DOCUMENT 00 91 02 – ADDENDUM NO. 2

PROJECT: Ord Village Lift Station & Force Main Replacement Project

CIP NO.: OS-0147

ISSUED: January 15, 2021

**ORD VILLAGE FORCE MAIN REPLACEMENT
 SEWER DETAILS (4 OF 4)**

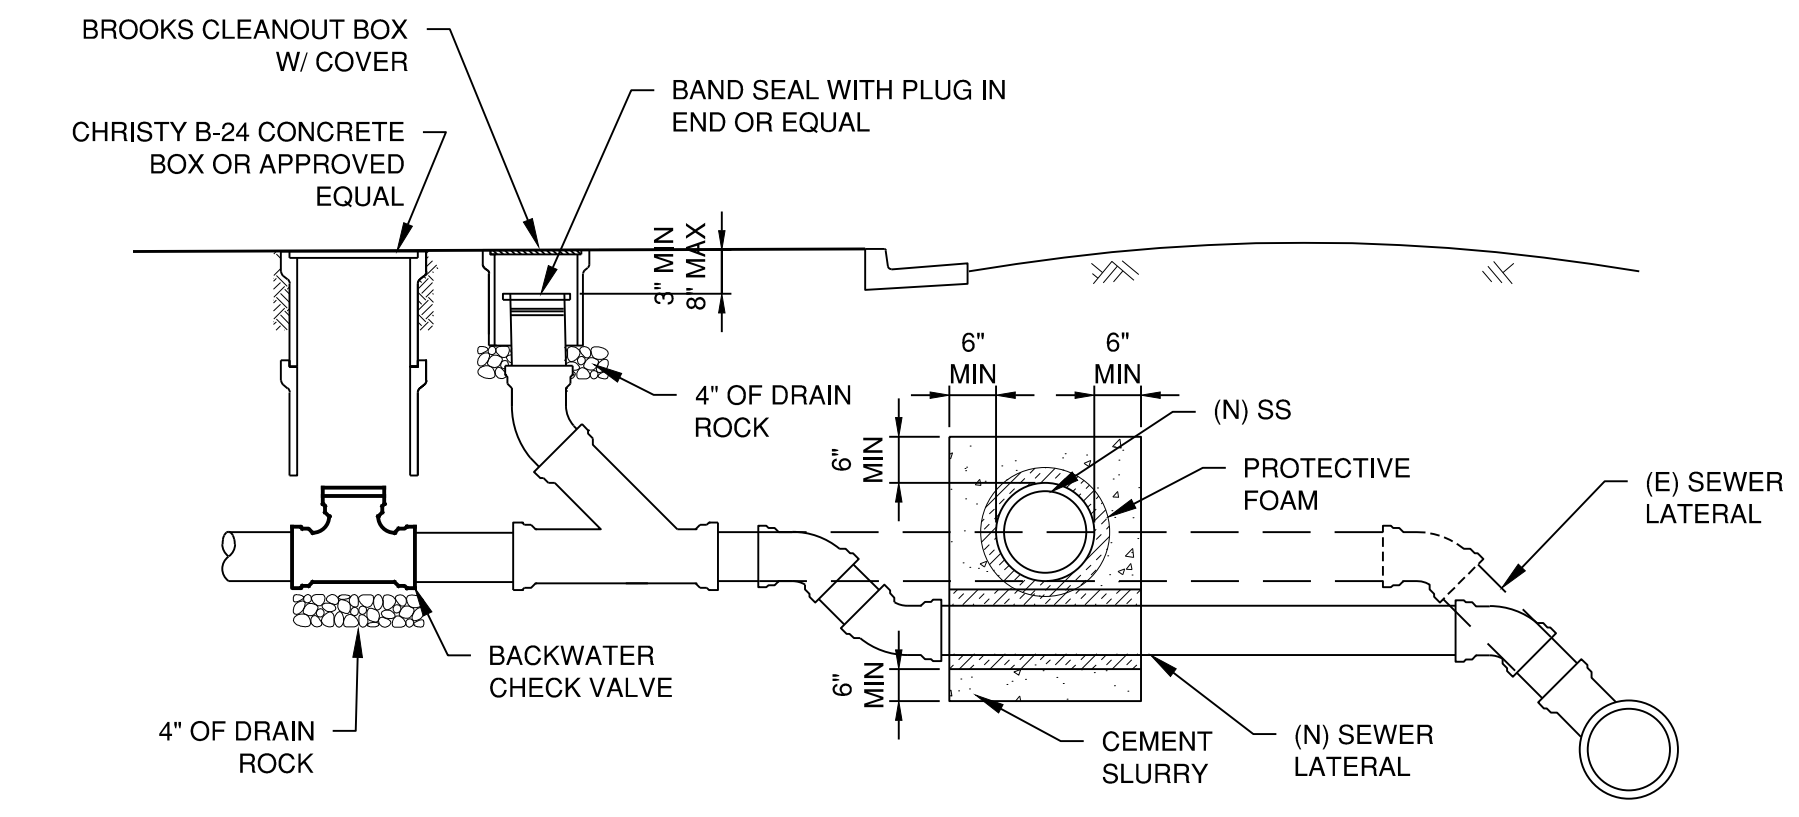
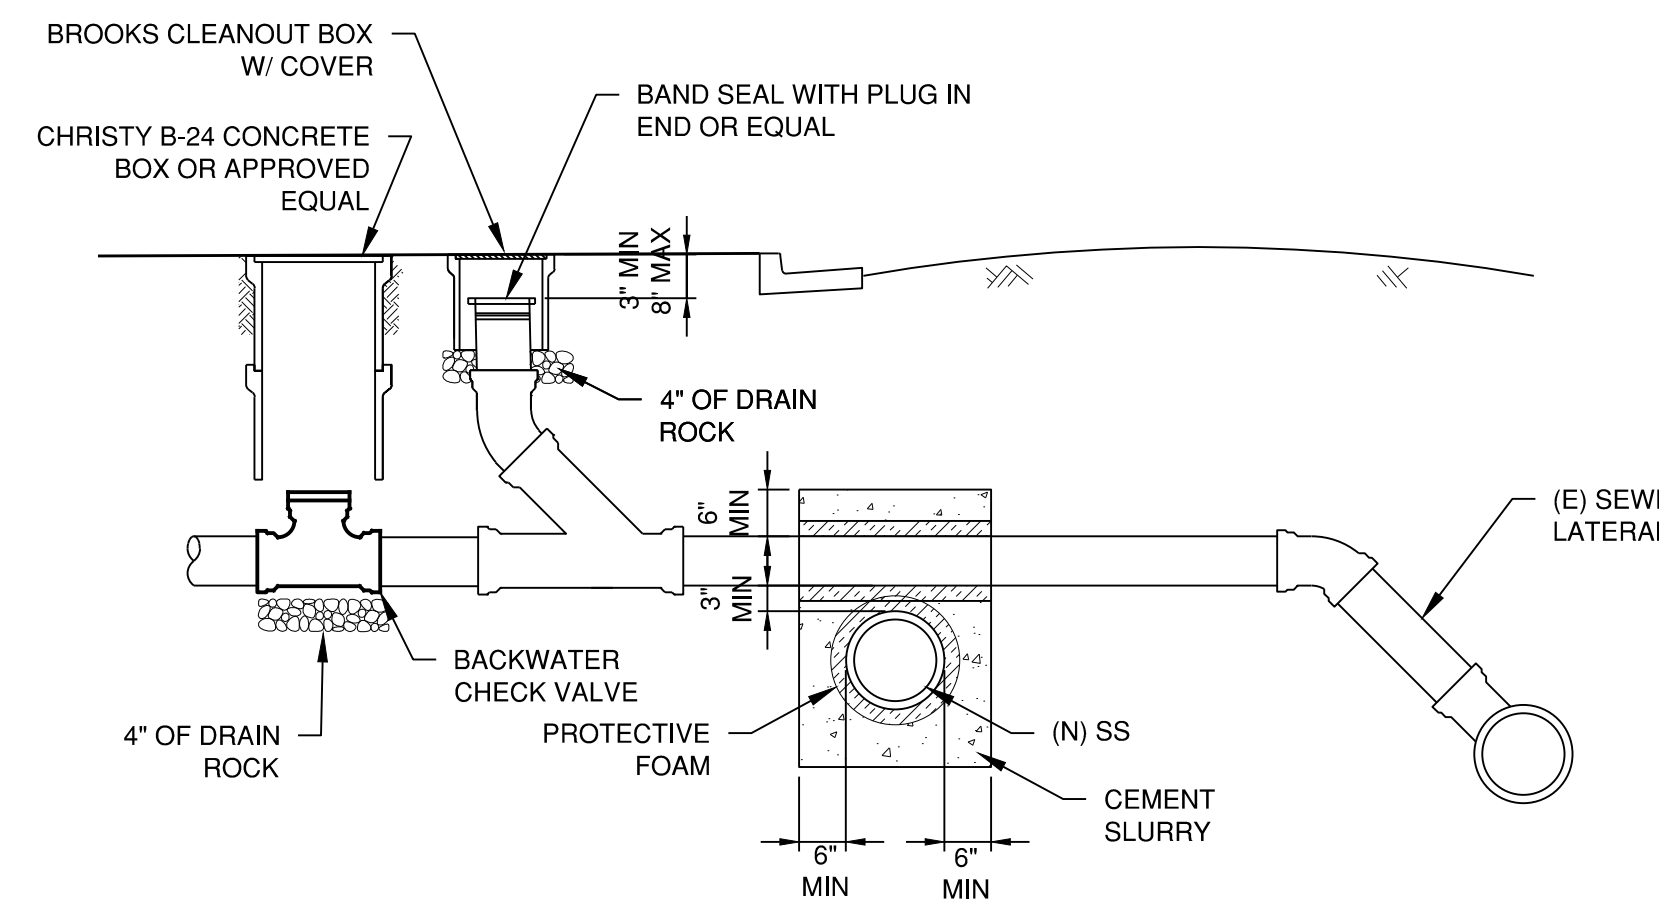
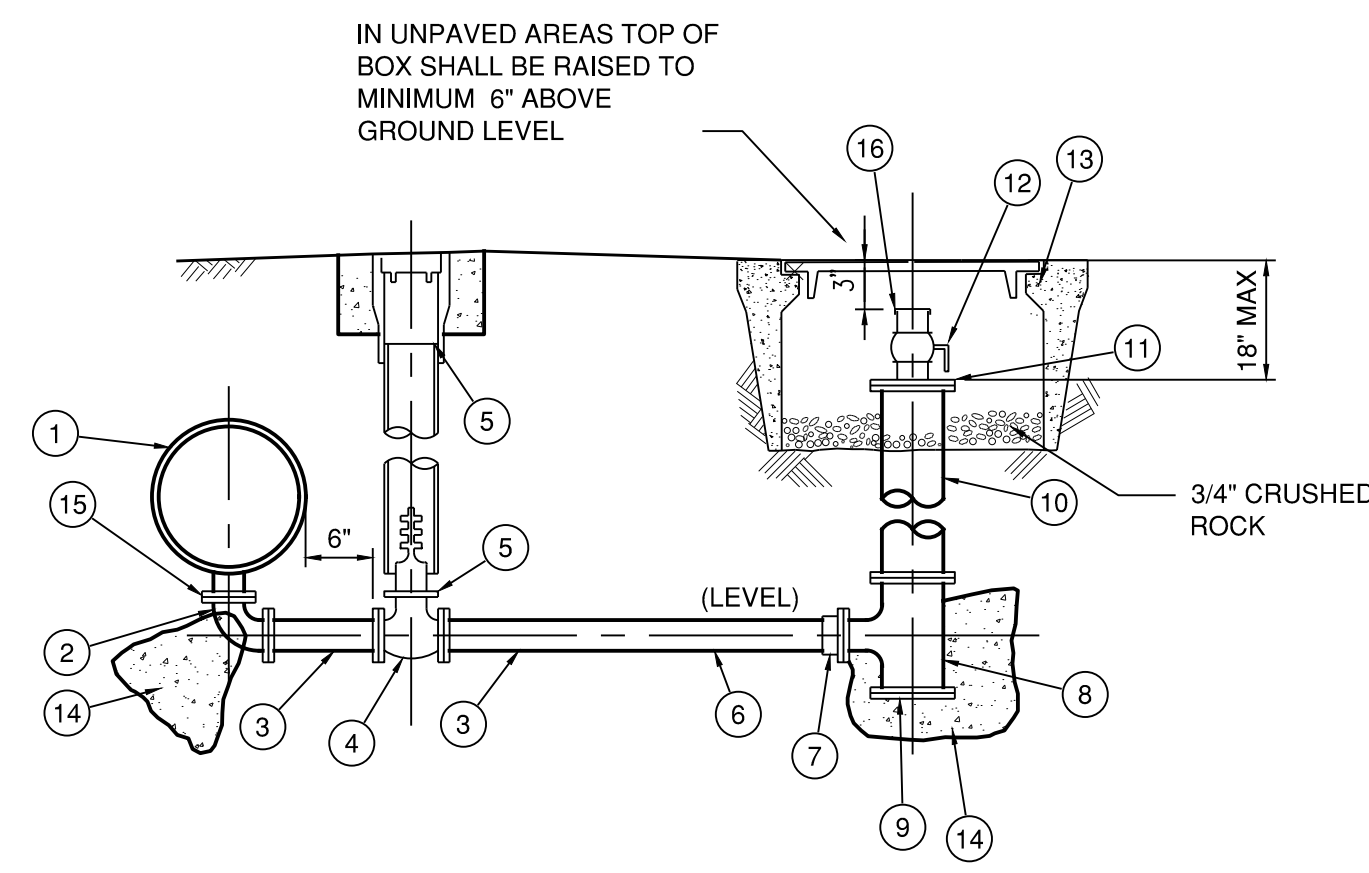
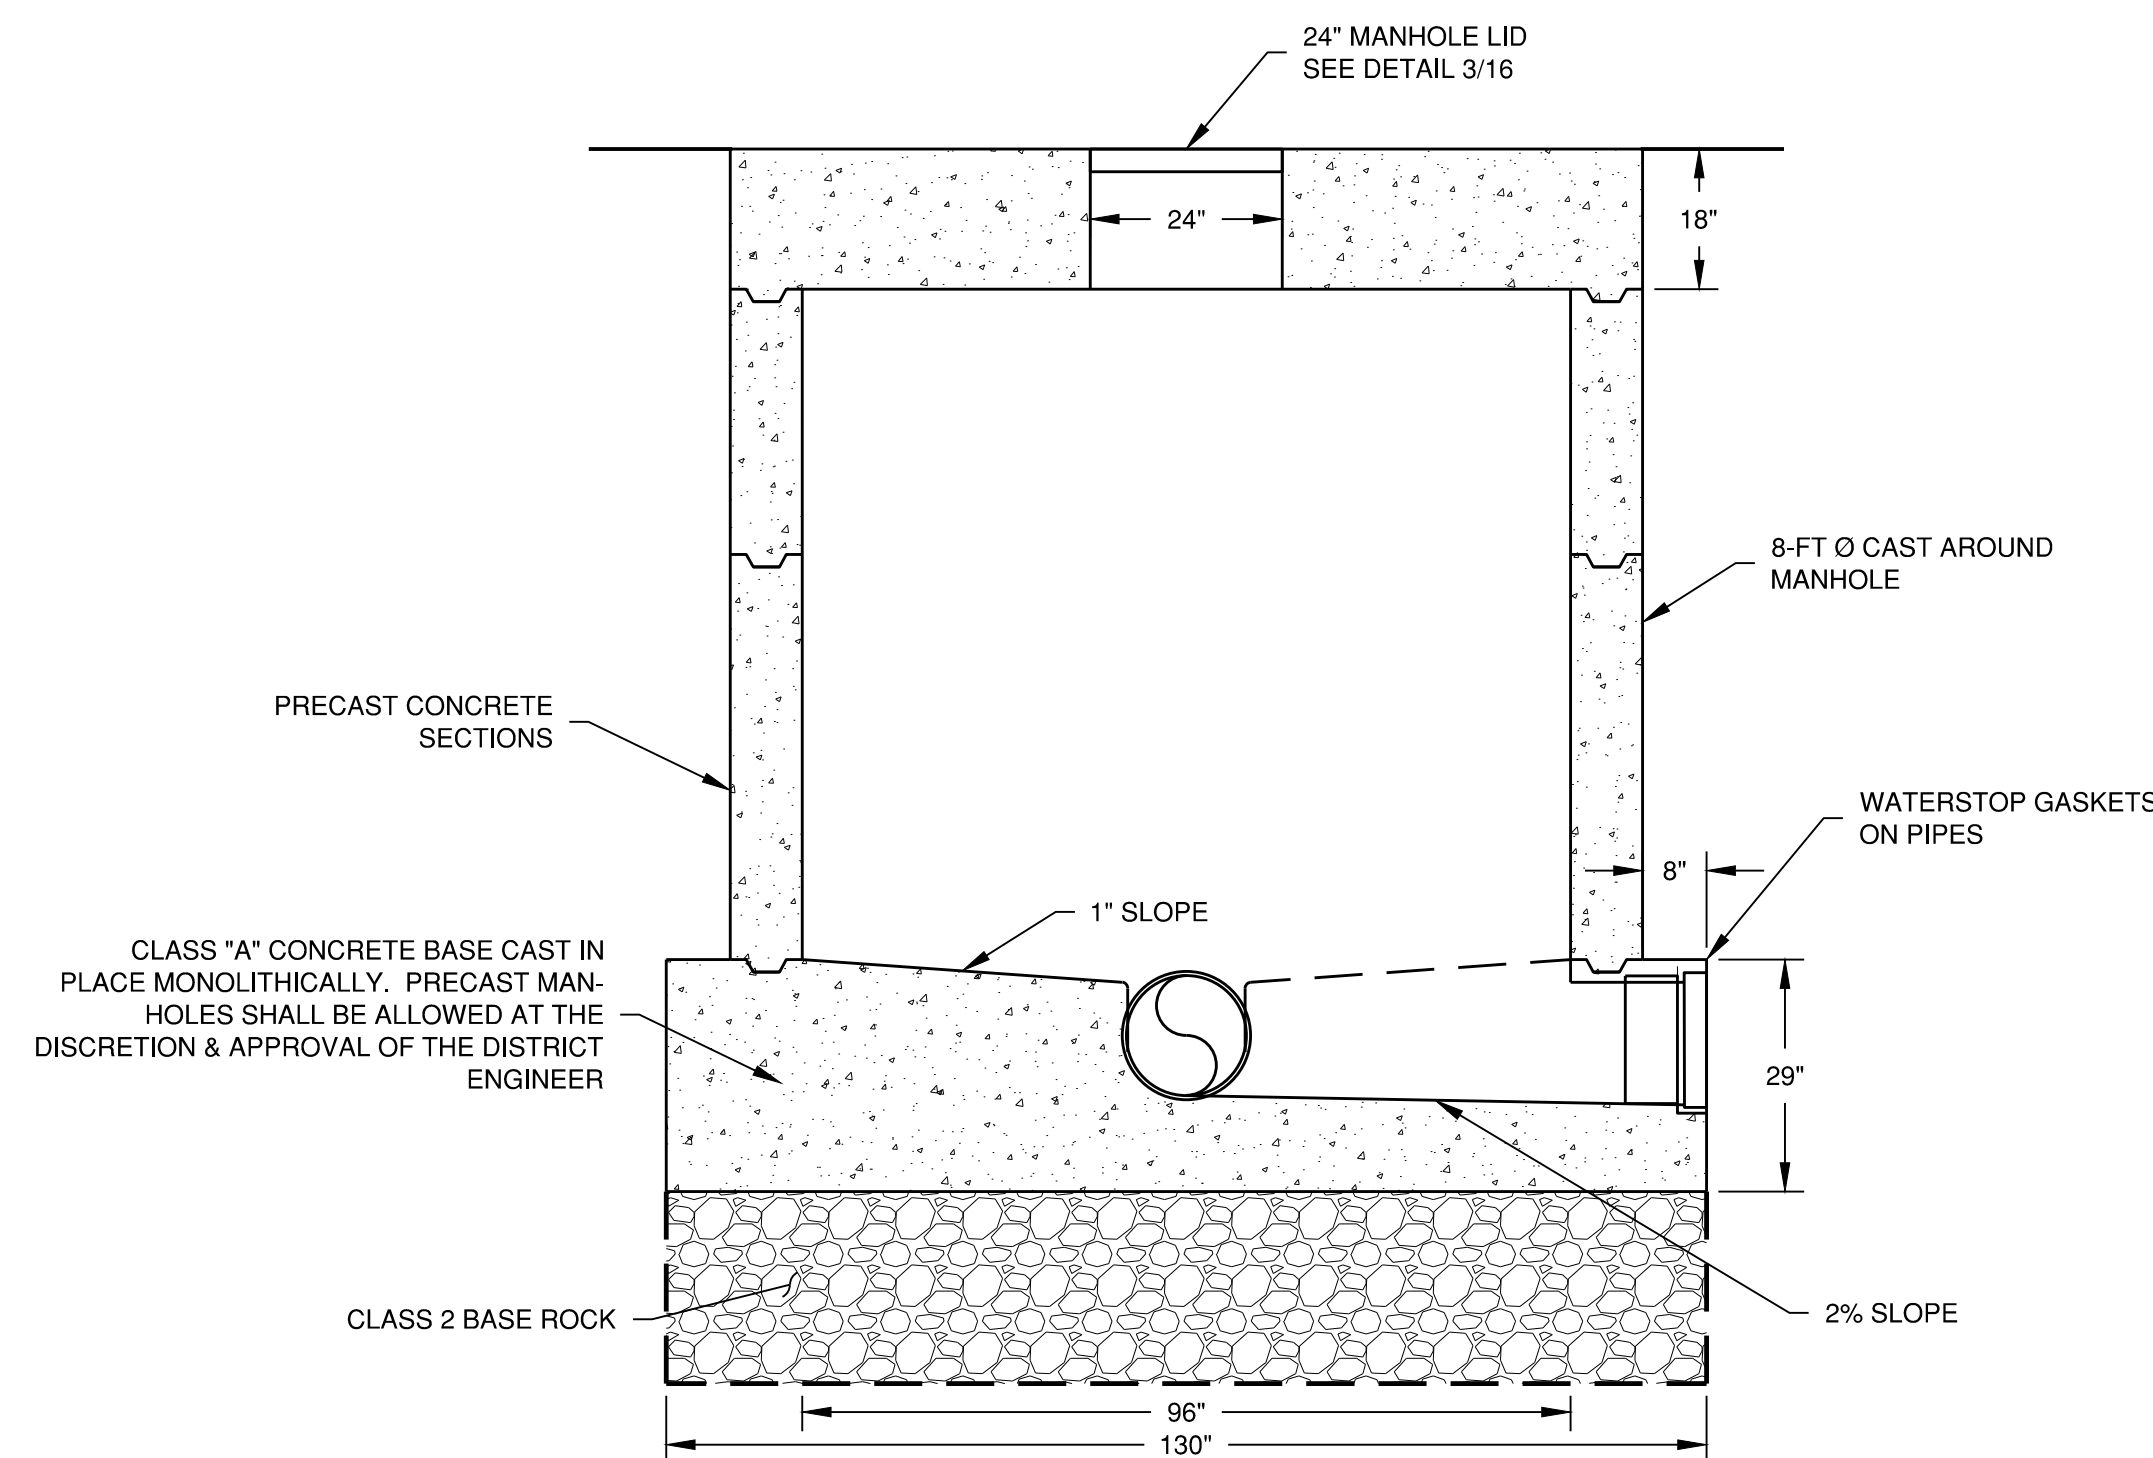
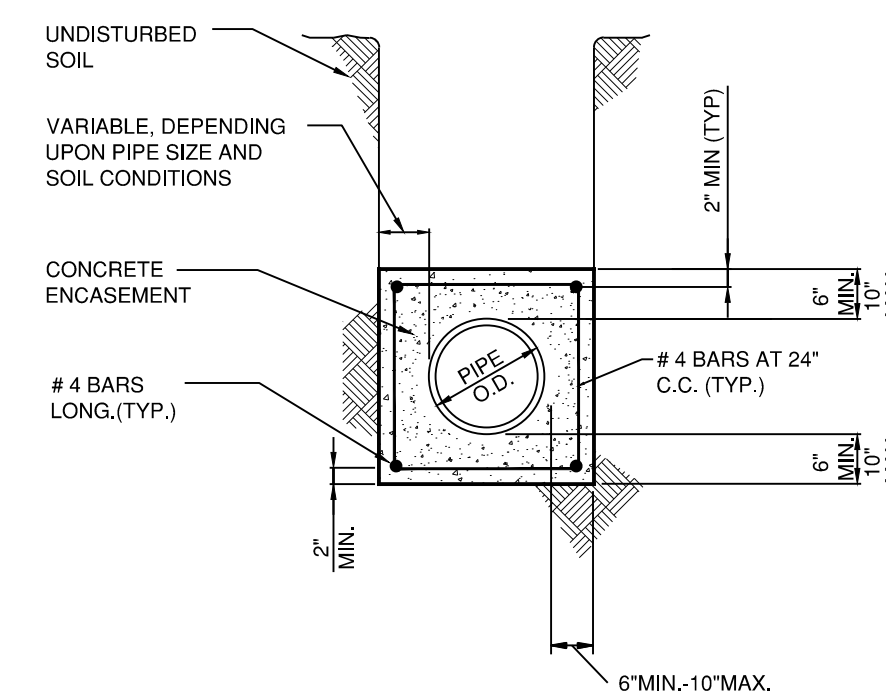
- A. Sheet 10, Plan & Profile (6 of 6) is reissued. A table of manhole depths is added.
- B. Sheet 15, Sewer Details (1 of 4), is reissued. Details for concrete foundation pads are added.
- C. Sheet 18, Sewer Details (4 of 4), is reissued. The label for Detail 1 is corrected.

Q5 Please provide a bid item and detail for the low point blow off on sheet 7 station 16+20.29.

Q21 Can you clarify the trench compaction requirements (Sheet 18, Detail 5)?

A5 The Blow-off Detail is mislabeled on Sheet 18. The corrected sheet is included in this Addendum. Include the cost of the Blow-Off in Bid Item 11, which is revised to include it.

A21 The detail shows both paved and unpaved areas. Compaction under and around the pipe is 95% Modified Proctor. Under pavement, the trench backfill is also at 95% Modified proctor. If not under pavement, the trench backfill is at 90% Modified Proctor.
